Re: Oil and Natural Gas Sector: Emission Standards for New, Reconstructed, and Modified Sources: Stay of Certain Requirements, 82 Fed. Reg. 51,788 (Nov. 8, 2017) (Docket No. EPA-HQ-OAR-2010-0505); and Oil and Natural Gas Sector: Emission Standards for New, Reconstructed, and Modified Sources: Three Month Stay of Certain Requirements, 82 Fed. Reg. 51,794 (Nov. 8, 2017) (Docket No. EPA-HQ-OAR-2017-0346)

GPA Midstream Association ("GPA Midstream") appreciates this opportunity to provide comments on the two Notices of Data Availability ("NODAs") published by the U.S. Environmental Protection Agency ("EPA") pertaining to the proposed three month and two year stay of the 2016 Oil and Gas New Source Performance Standards. 81 Fed. Reg. 35,824 (June 3, 2016) ("2016 Rule" or "Subpart OOOOa Rule" or "OOOa Rule"). 82 Fed. Reg. 51,788 ("Two-Year Stay"); 82 Fed. Reg. 51,794 ("Three-Month Stay").

GPA Midstream (f/k/a Gas Processors Association), Submission to Administrative Record of Supplemental Comments on Oil and Gas Sector: Emission Standards for New and Modified Sources, Proposed Rule (Docket EPA-HQ-OAR-2010-0505)

Attachment B: Pneumatic Pumps at Example Compressor Station with Nine Compr

Exhibit

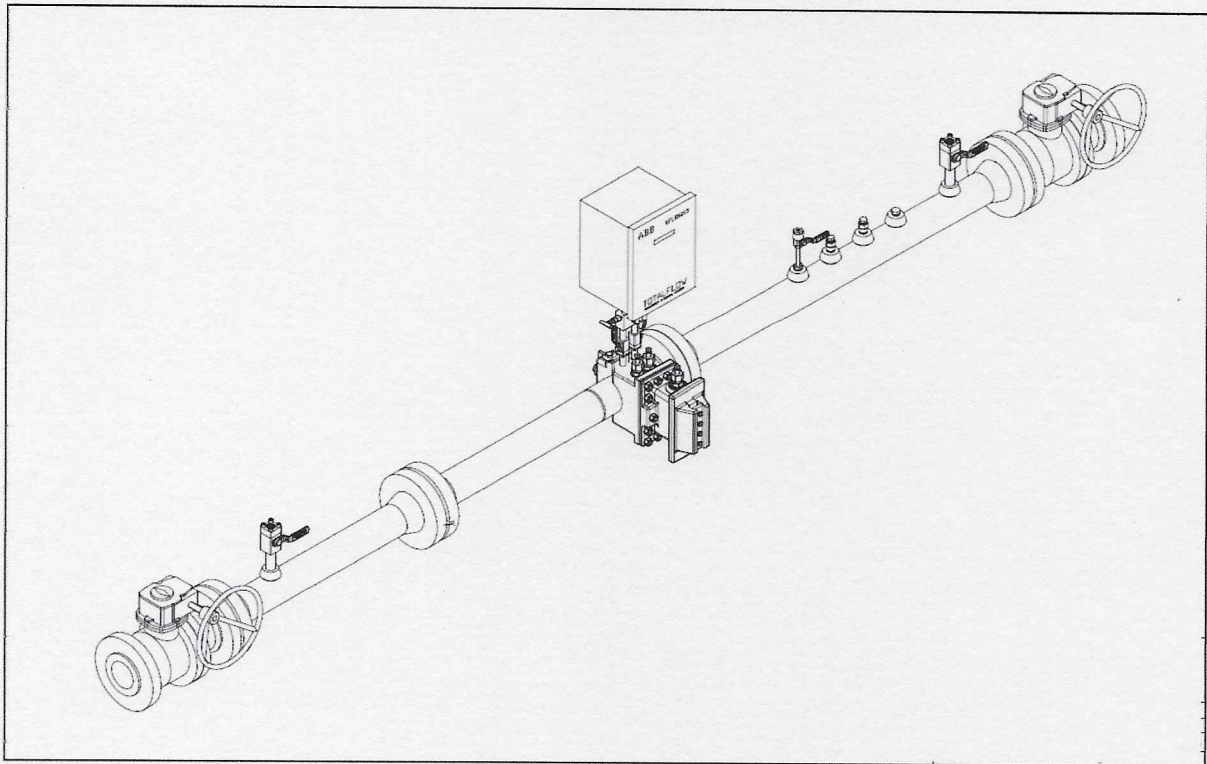
A typical gas gathering meter run is discrete, small in size, and is shown in the attached Exhibit. The following cost analysis is conservatively low and effectively overstates the cost effectiveness figures for gathering system meter OGI because, while it does not include the small amount of natural gas that may be saved by completing repairs, it also does not account for gas/production lost by necessity during repairs, the latter of which is estimated to have a significantly higher cost impact since many, if not all, meter repairs will require production from producing well(s) associated with an individual gathering system meter(s) to be shut down during the repair and the meter to be blocked-in and depressurized to effect the repairs. At \$7,731 per tpy for annual, \$10,309 per tpy for semi-annual, and \$15,463 per tpy for quarterly LDAR OGI, imposing such requirements on midstream gathering meters LDAR is not cost effective by EPA's stated standards.
